Revised Drainage Plan
 FOR THE M.P.G. BUILDING
 6819 ACADEMY PARKWAY WEST NE
 ALBUQUERQUE, NEW MEXICO

PROJECT: 10251
 DATE: 9 DEC 1982
 DRAWN: M.H. REALE
 CHECKED: SCORING
 REVISIONS:

SITE PLAN

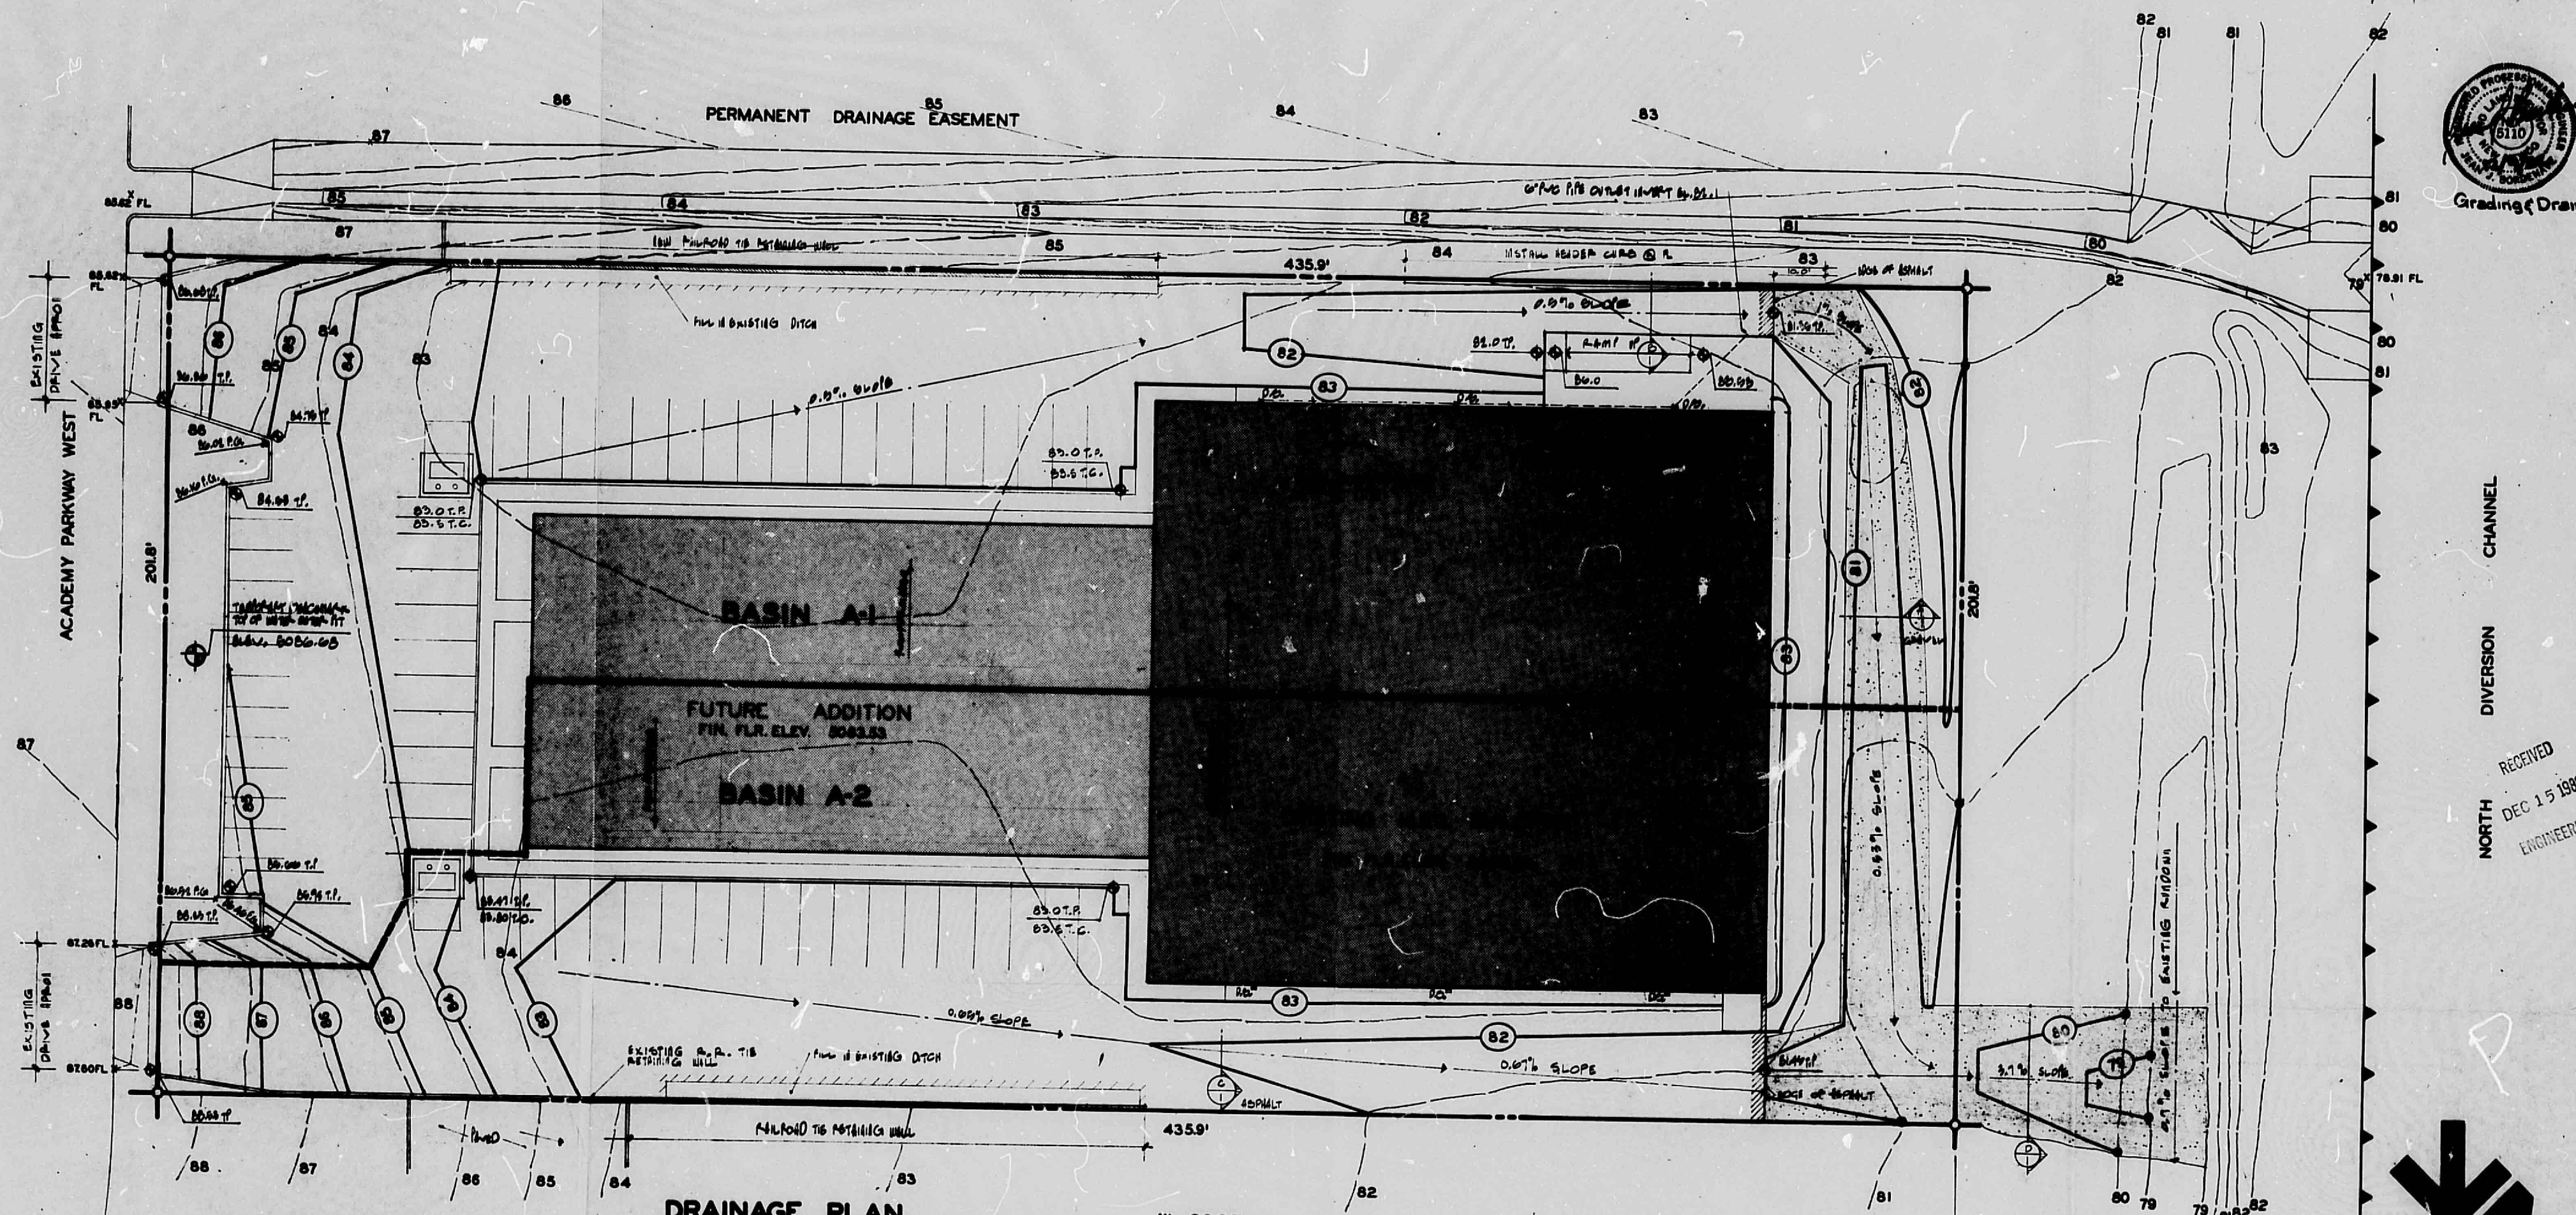
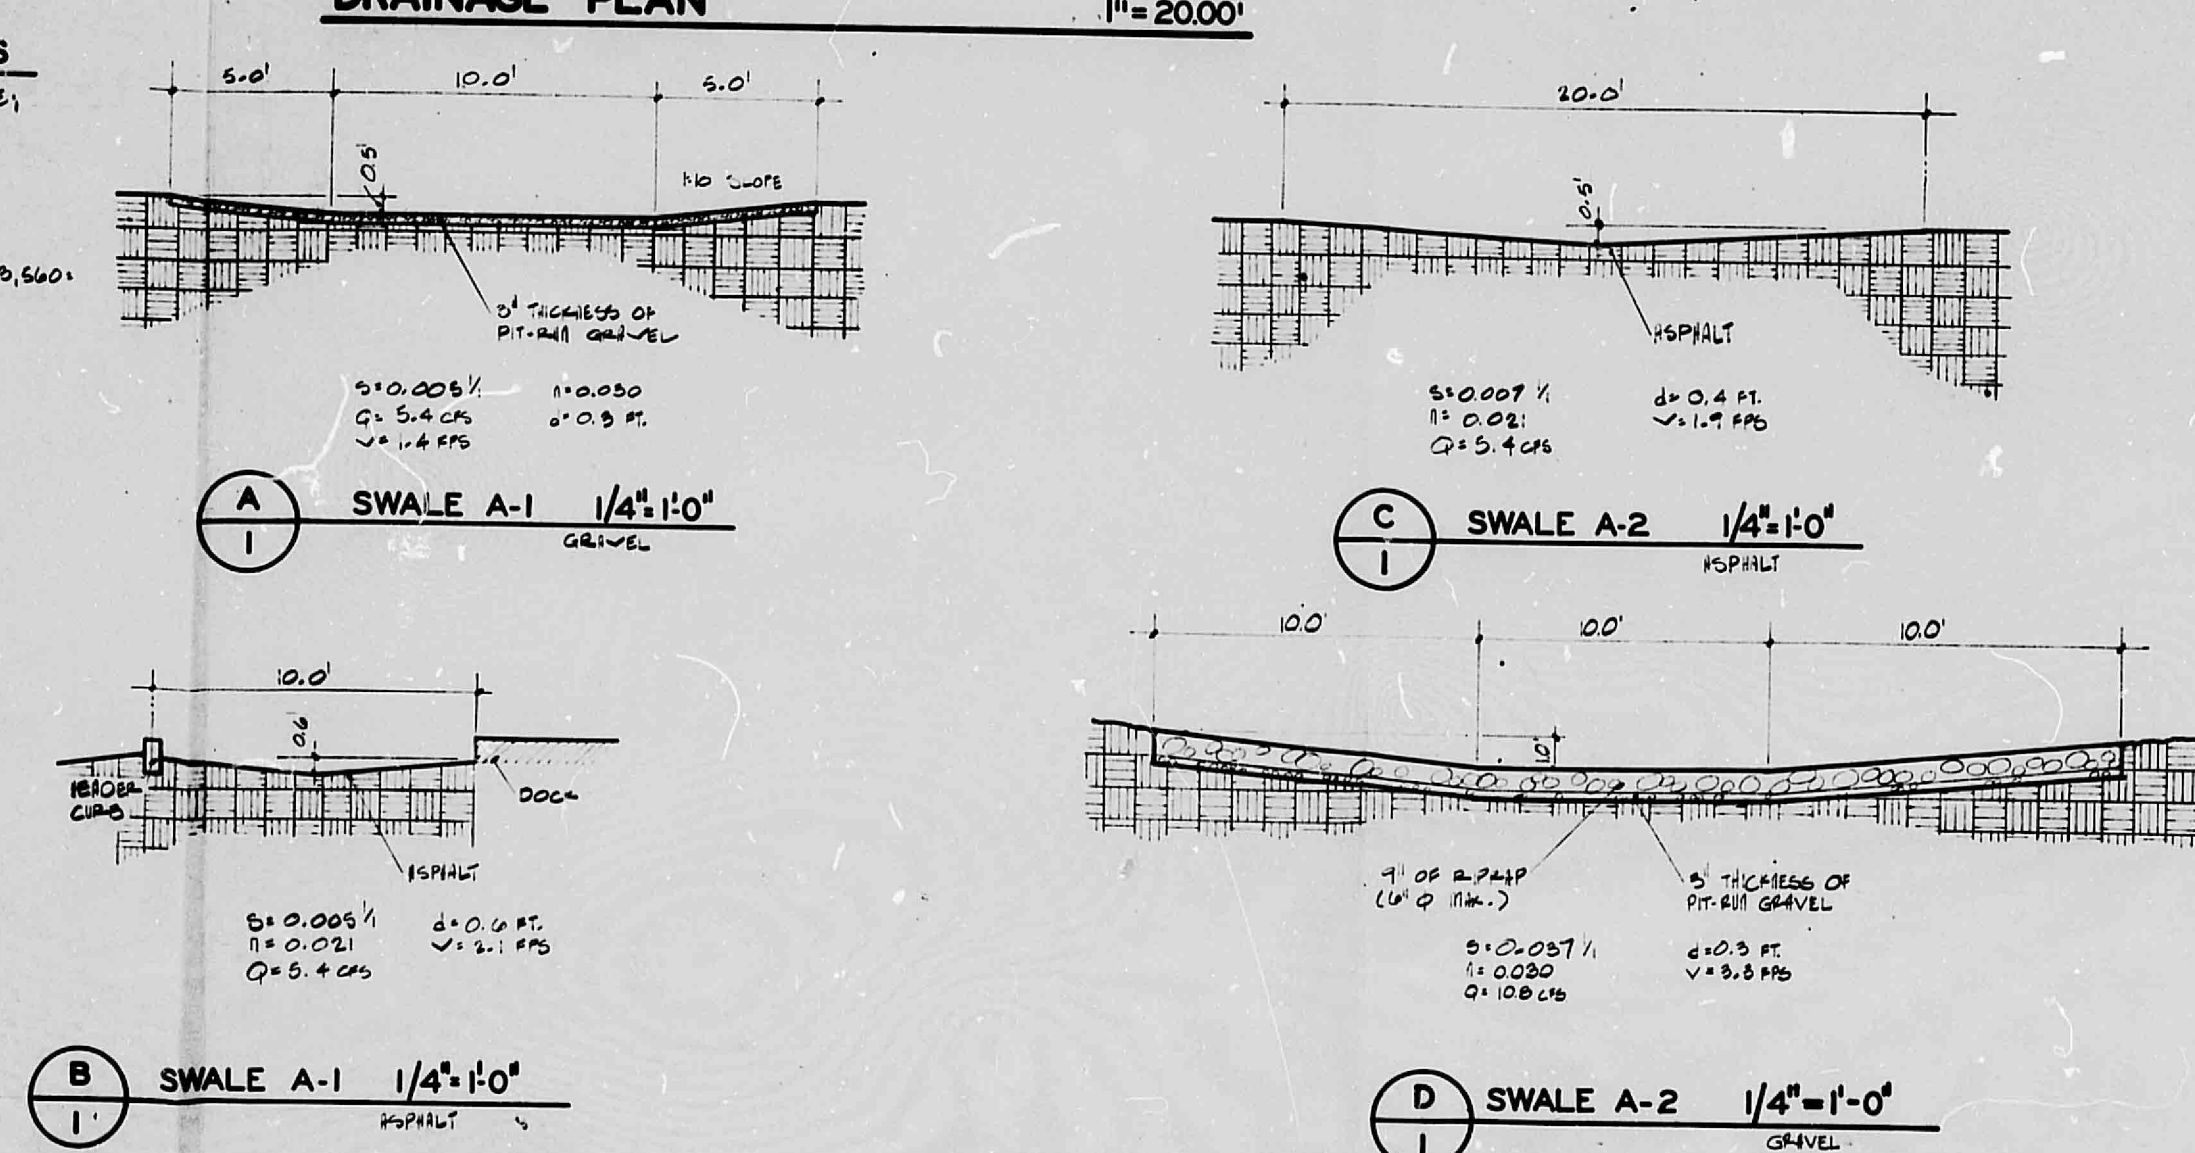
Approved for AMAFCA
 Requirement 12/14/82
 DaSilva

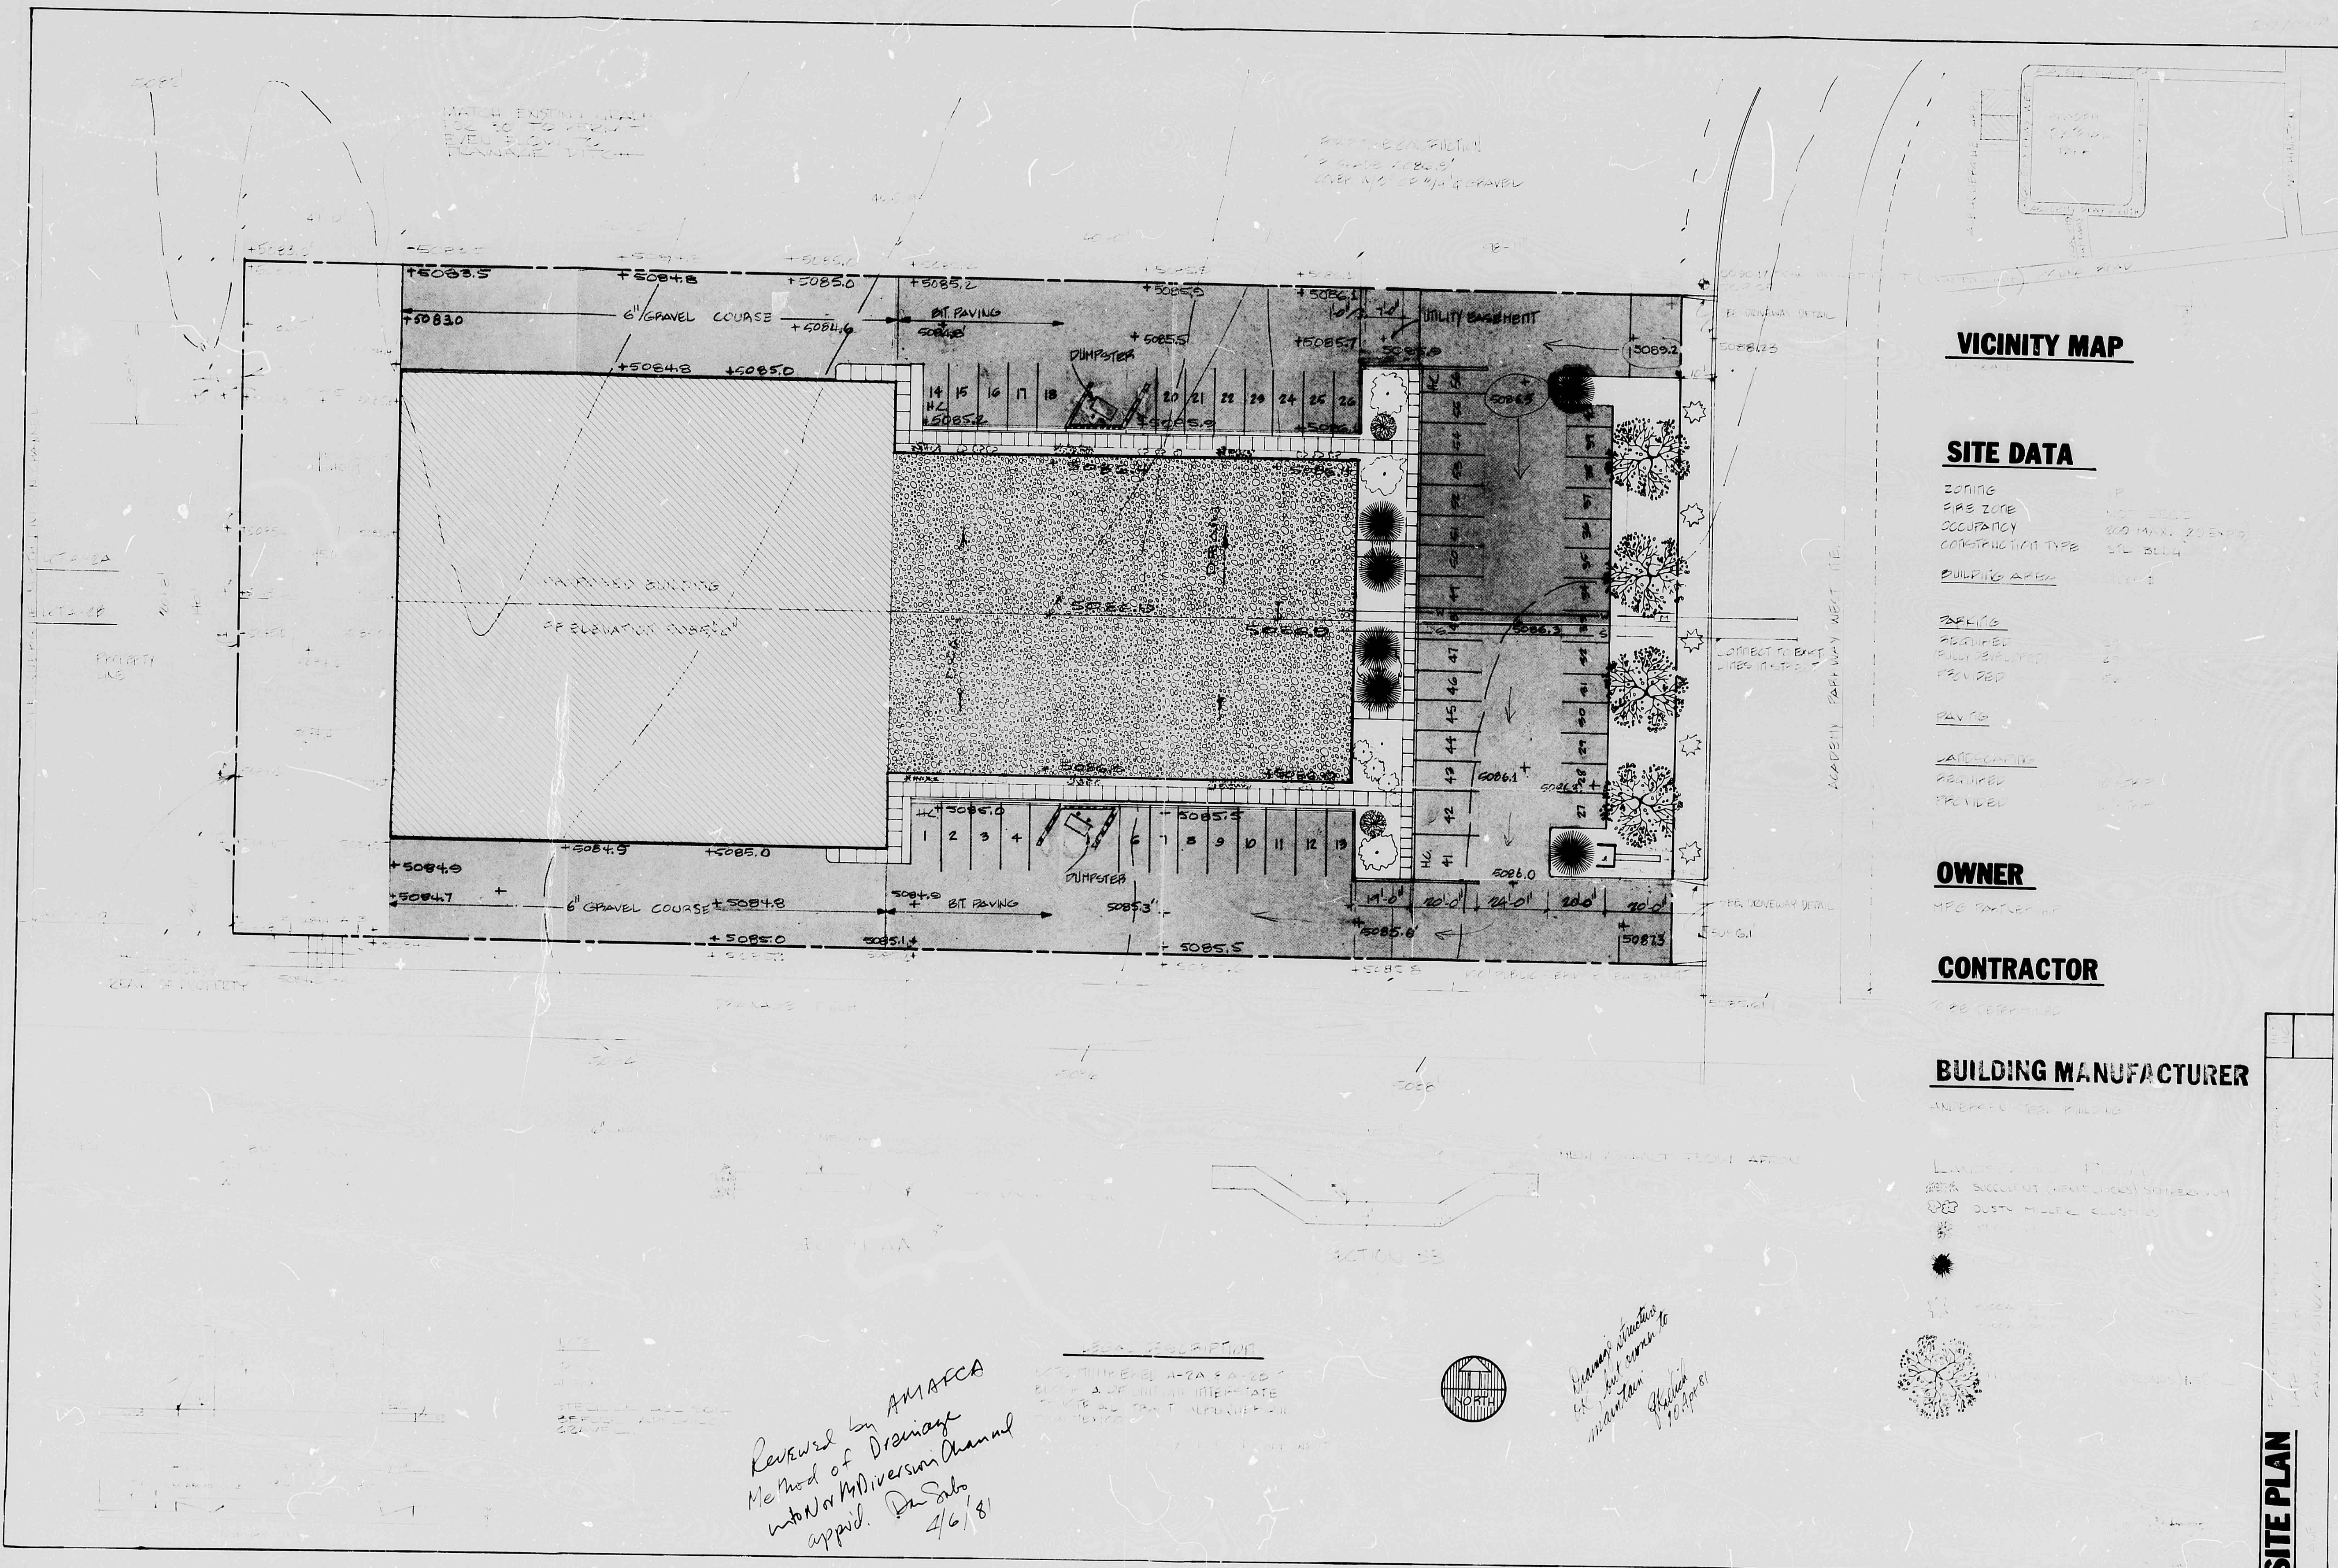
*Reviewed by AMATCA
 Method of Drainage
 with a 14" diversion channel
 app'd. DuSals
 4/6/81*

*Review structure
 OK for water to
 maintain
 10/20/81*
